IREDELL COUNTY HEALTH DEPARTMENT

IMPROVEMENT PERMIT / AUTHORIZATION TO CONSTRUCT / OPERATION PERMIT / EXISTING SYSTEM INSPECTION

PERMIT# 110299 PIN# 4756-68-4429 DATE 12-30-02

SUBDIVISION BAYMOUNT STONE HOMES SECTION ____ LOT 128 LOT AREA .96 AC SITE CLASS PS DESIGN FLOW 480 L.T.A.R. .3

INITIAL SITE SKETCH

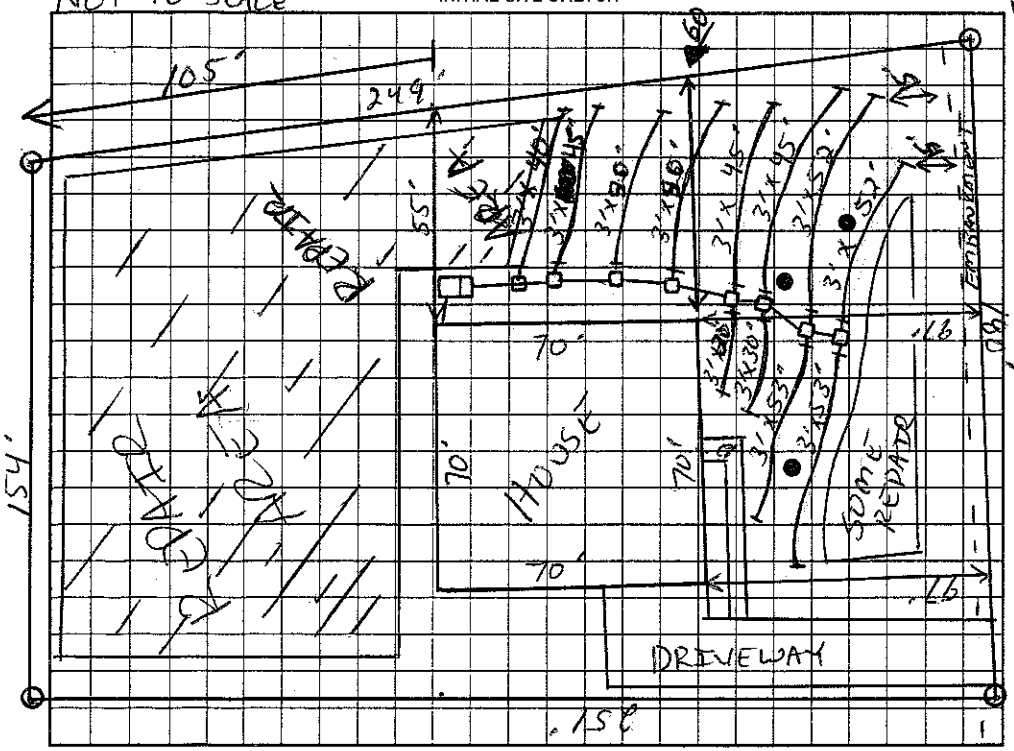
Comments/Conditions: (1) MAINTAIN SETBACKS (2) HOUSE HAS SLID BACK 20' FROM ORIGINAL STAKES ON LOT. DRAWING BELOW IS ACCURATE. (3) KEEP LINES 15' OFF TOP OF EMBANKMENT CUT. (4) HOUSE & LINES ARE "NOT TO SCALE"

Comments/Conditions: COMPLETELY SHOT IN. (5) BLACK DOT'S BETWEEN LINES ARE TREE'S (6) LINE #1 IS NOT FLAGGED. CALL PRIOR TO INSTALLATION TO BE FLAGGED IF NEEDED (7) KEEP H2O LINE 10' FROM ANY PART OF THE SYSTEM.

(X) 8 LINES
1ST LINE = 40'
2nd LINE = ~~45~~ 40'
3rd LINE = ~~50~~ 48'
4th LINE = ~~50~~ 65'
5th LINE = ~~65~~ 70'
6th LINE = ~~75~~ 80'
7th LINE = ~~105~~ 90'
8th LINE = 105'
TOTAL = ~~535~~ 538'

(1) SEPTIC TANK WITH MARKER INSTALLED USING "TUFTITE" FILTER
(3) SYSTEM INSTALLED ACCORDING TO INITAL SITE SKETCH
